March 8, 2013

RE: Alamo Permian – State BK #9

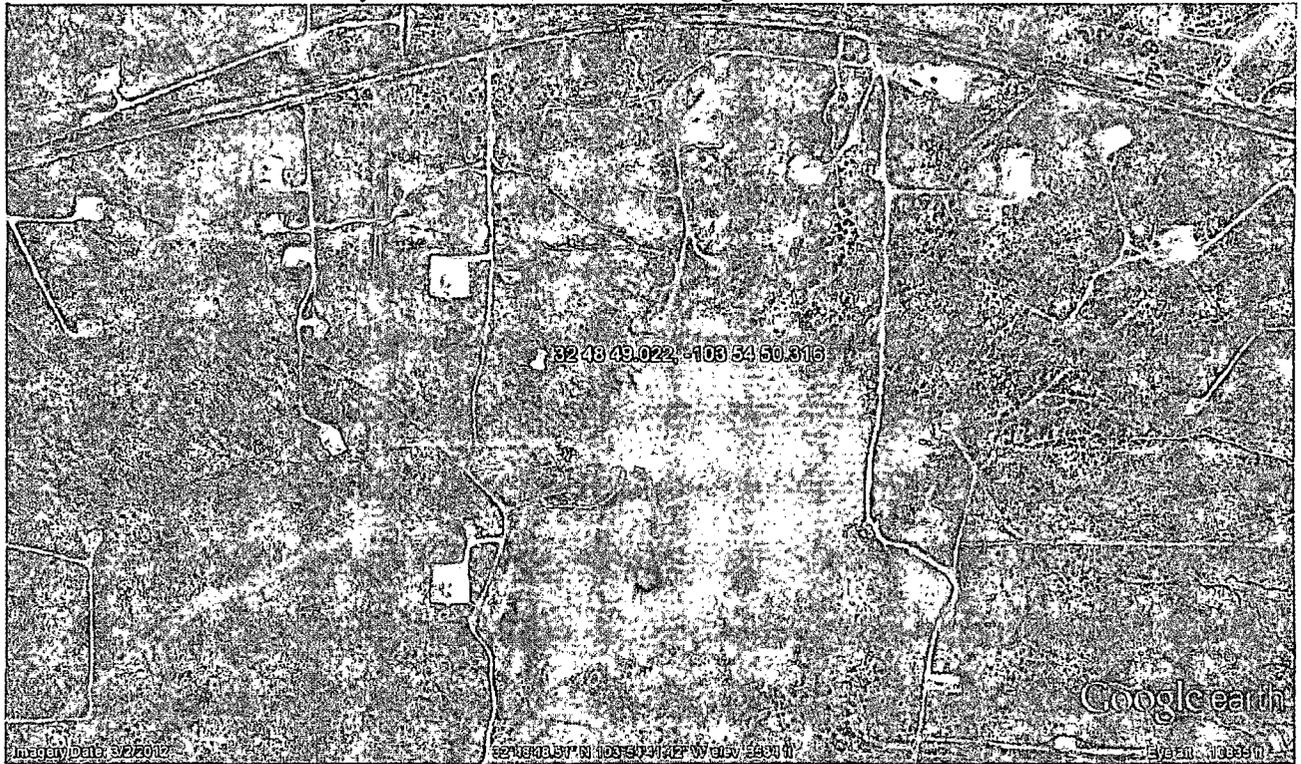
The aerial photograph below is reproduced from the 1971 Eddy County Soil Survey. The location of the State BK #9 proposed temporary pit lies within the red circle with the larger drainage just north of the circle. No drainage is evident in the area of the State BK 9 location. This map identifies drainages entering the ancient lake bed and a channel draining the ancient lakebed (north and west of the W in the center of the map). The scientists who created this map did not identify a drainage near State BK 9.

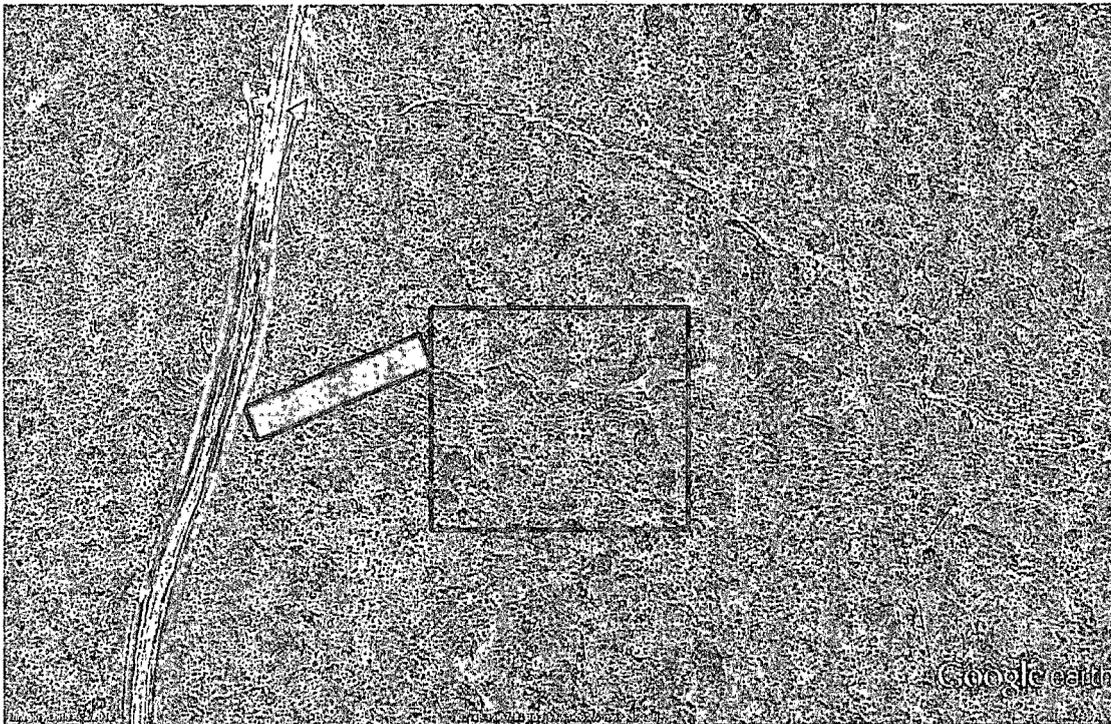
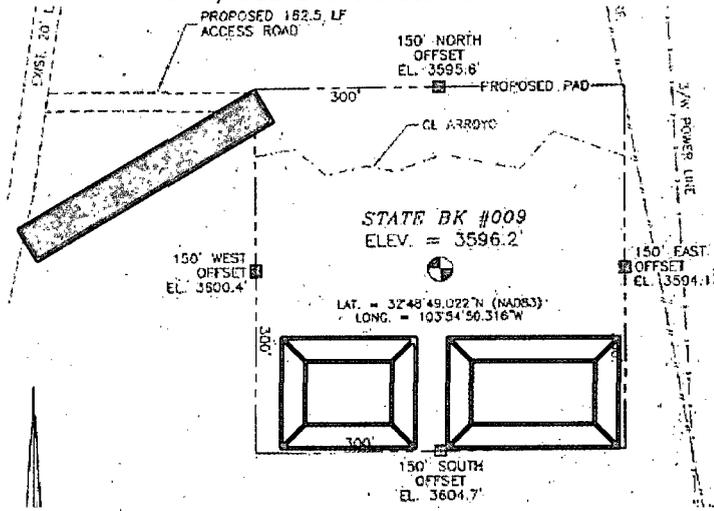
Here is the survey of the site with the pit show. Note the Arroyo shown on the survey – this must be filled to build the location. The Google map below the survey shows the same area. The 150 south survey benchmark is 8 feet higher than the well marker – the pit is built into the side of a dune. Also shown below is my idea for the access road. Now look below at the Google Image.

PRELIMIARY DESIGN - Sweatt creates one or two small bar ditches on each side of the road that direct drainage to the larger arroyo to the north. This water diversion will be necessary with pits or closed loop. In the absence of water diversion, one frog strangler rain will take out the northern portion of the location – probably in July, after construction of the tank battery. In essence, this diversion restores some of the drainage pattern observed in the 1971 Soil Survey map.
